Access Compliance Report

Public Rights-of-Way

(Curb Ramps)

Intersection ID: 46684	Main Street: ABODE_LILY_LN	Cross Street: JEWELFLOWER_RD	Location: NE
ADA ID: 0C88AA410E5D	Ramp Type: PerpDiag	Initial Pass/Fail: Fail	Overall Compliance: No
Severity Score: 13.75			
Codes/Mitigation Info/Possible Solution		Field Measurements/Component Compliance

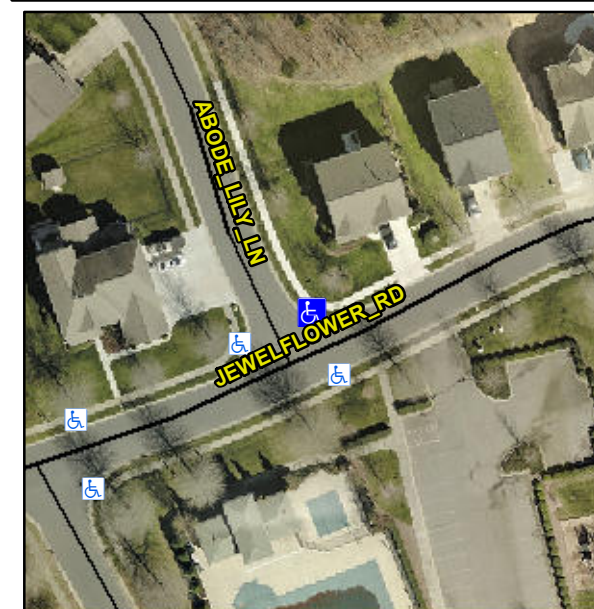
Not Found, R304.2.2, R304.5.3

Compliance	Description	Data	Compliance	Description	Data
N/A	Ramp Length (in)	47.5	No	Ramp Slope (%)	9.2
Yes	Ramp Width (in)	48.0	No	Ramp XSlope (%)	2.5
N/A	Flare Type LT	N/A	N/A	Flare Type RT	N/A
N/A	Flare Slope LT (%)	N/A	N/A	Flare Slope RT (%)	N/A
N/A	Flare Traversable LT?	N/A	N/A	Flare Traversable RT?	N/A
N/A	Landing Length (in)	N/A	N/A	DWS Provided?	N/A
N/A	Landing Width (in)	N/A	N/A	DWS Contrast?	N/A
N/A	Landing Slope (%)	N/A	N/A	DWS Length (in)	N/A
N/A	Landing X Slope (%)	N/A	N/A	DWS Full Width?	N/A
N/A	Landing Curb? (Y/N)	N/A	N/A	DWS Offset (in)	N/A
N/A	Shared Landing?	N/A			
N/A	Gutter Ponding?	N/A	N/A	Gutter Slope (%)	N/A
N/A	Gutter Lip Ht (in)	N/A	N/A	Gutter X Slope (%)	N/A
N/A	Painted X Walk1?	No	N/A	Painted X Walk2?	No
	X Walk 1 Direction	To W		X Walk 2 Direction	To S
N/A	X Walk 1 Width (in)	N/A	N/A	X Walk 2 Width (in)	N/A
	X Walk 1 Slope (%)	2.1		X Walk 2 Slope (%)	1.1
	X Walk 1 X Slope (%)	0.7		X Walk 2 X Slope (%)	0.9

Remove & Replace Curb Ramp With Two New Directional Ramps or Equivalent.
